CHANGE ORDER APPROVAL FORM

PROJECT: CR-108 Milling & Resurfacing

CHANGE ORDER NUMBER: 06

Description: *Add guardrail on right side @ 72" culvert.*

**DETAIL FOR INSTALLATION
OF ADDITIONAL GUARDRAIL**

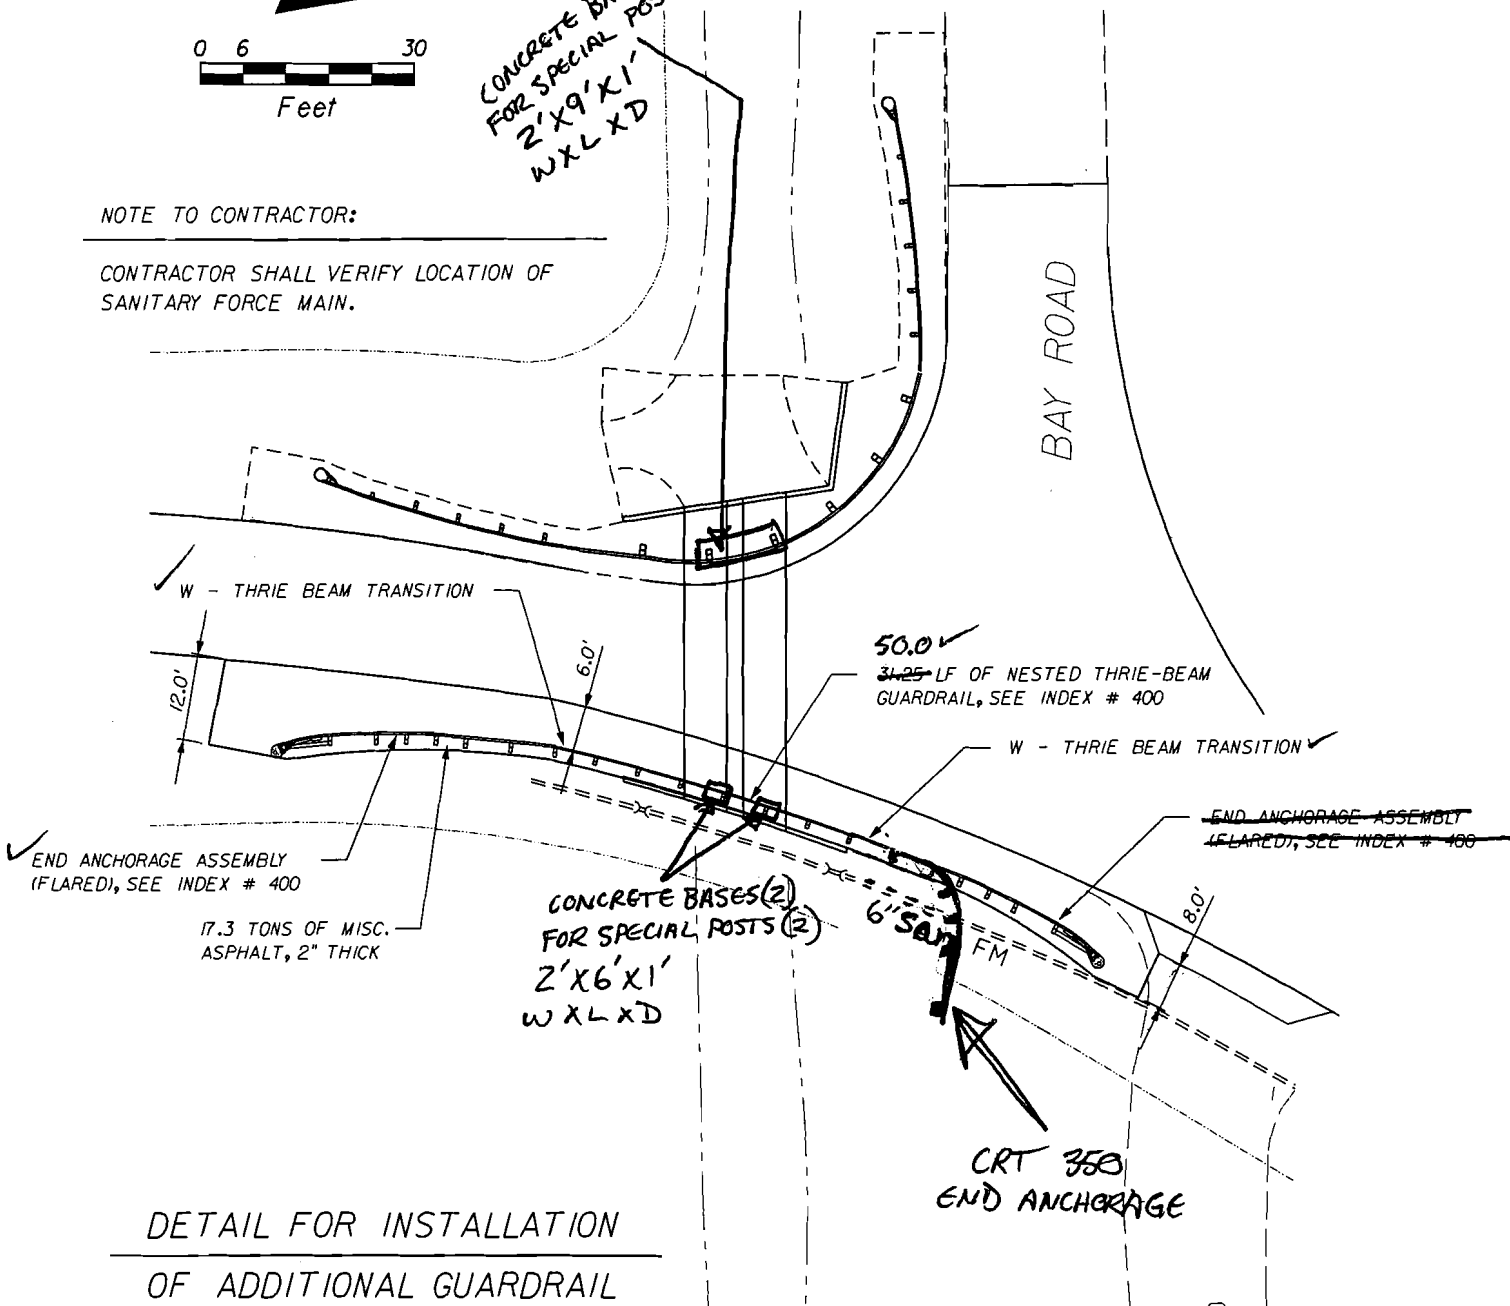
CONTRACTOR SHALL VERIFY LOCATION OF
SANITARY FORCE MAIN.

- 500 LF NESTED THRIE BEAM GUARDRAIL
- 2 EA W-THRIE BEAM TRANS. (6.25')
- 1 EA END ANCHORAGE ASSEMBLY (FLARED)
- 1 EA END ANCHORAGE ASSEMBLY (CRT 350)
- 2 EA SPECIAL POSTS
- 2 EA CONCRETE BASES FOR SPECIAL POSTS

17.3 TONS OF MISC.
ASPHALT, 2" THICK

CONCRETE BASES (2)
FOR SPECIAL POSTS (2)
2' X 6' X 1'
W X L X D

50.0' ✓
~~31.25~~ LF OF NESTED THRIE-BEAM
GUARDRAIL, SEE INDEX # 400

**DETAIL FOR INSTALLATION
OF ADDITIONAL GUARDRAIL**

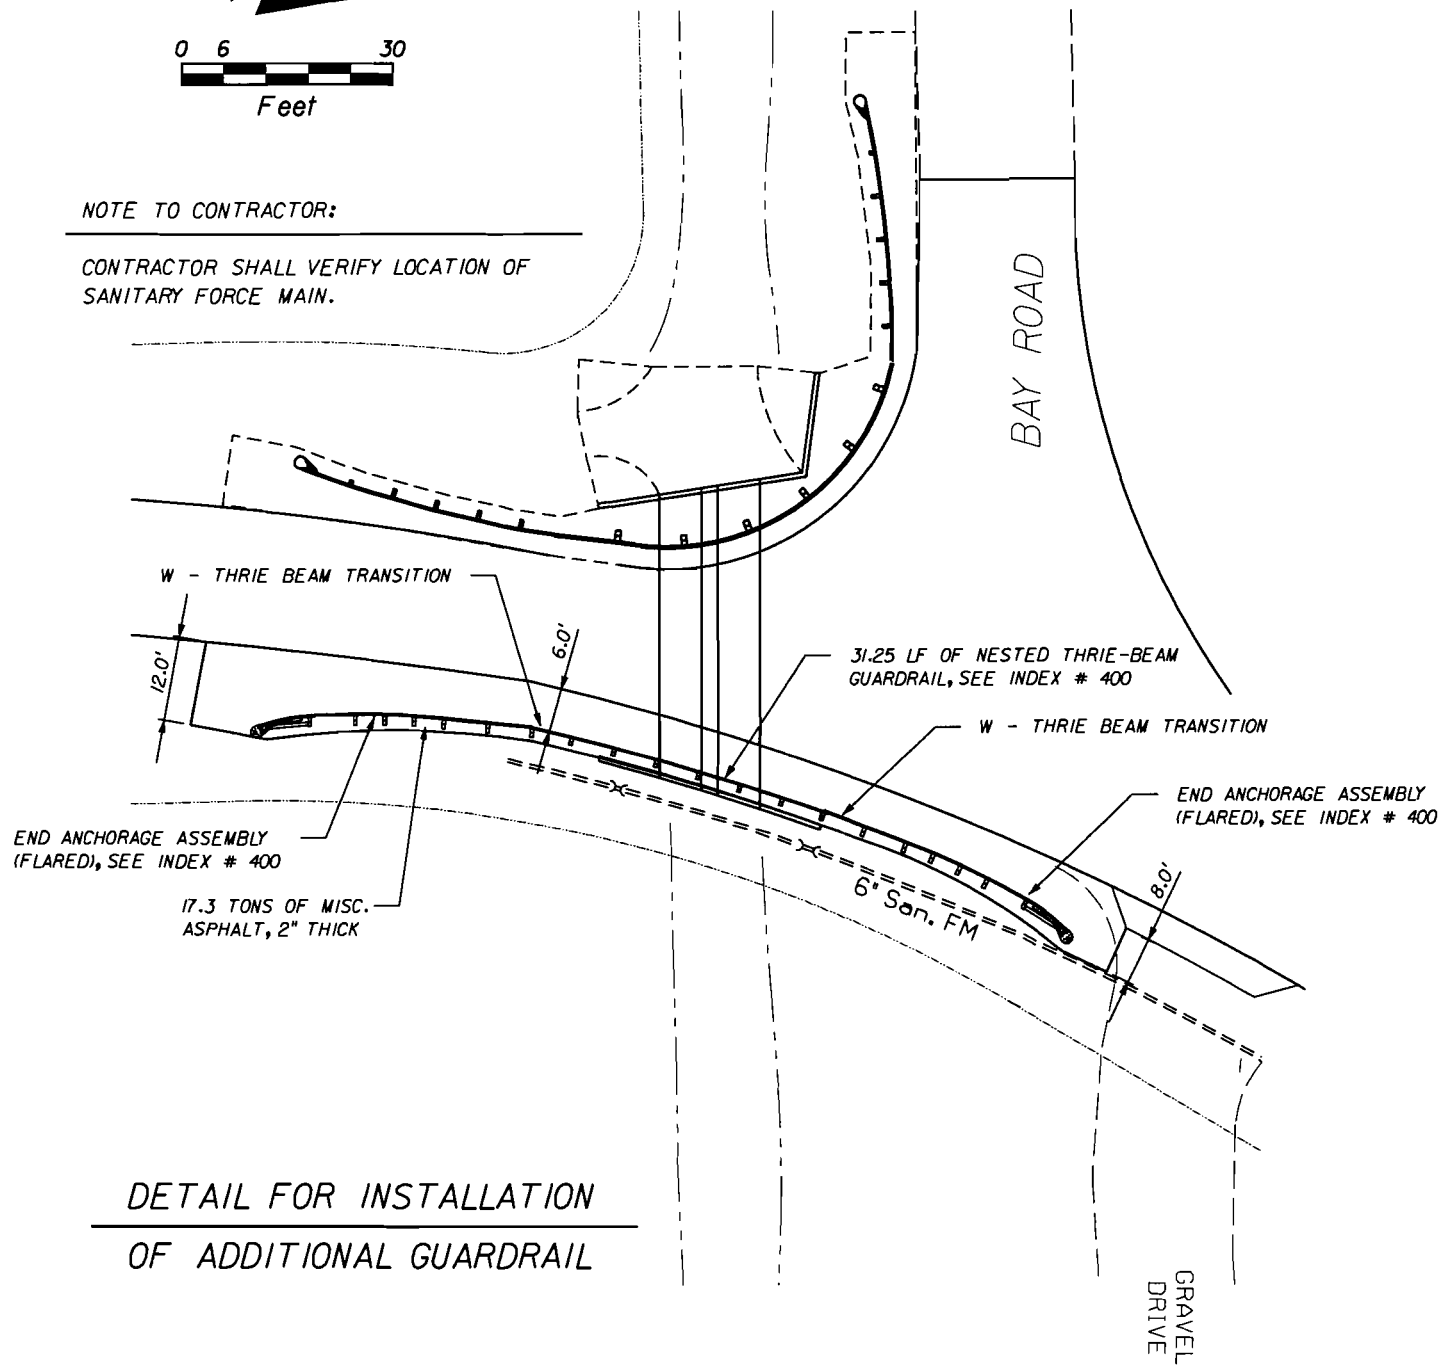
CONTRACTOR SHALL VERIFY LOCATION OF
SANITARY FORCE MAIN.
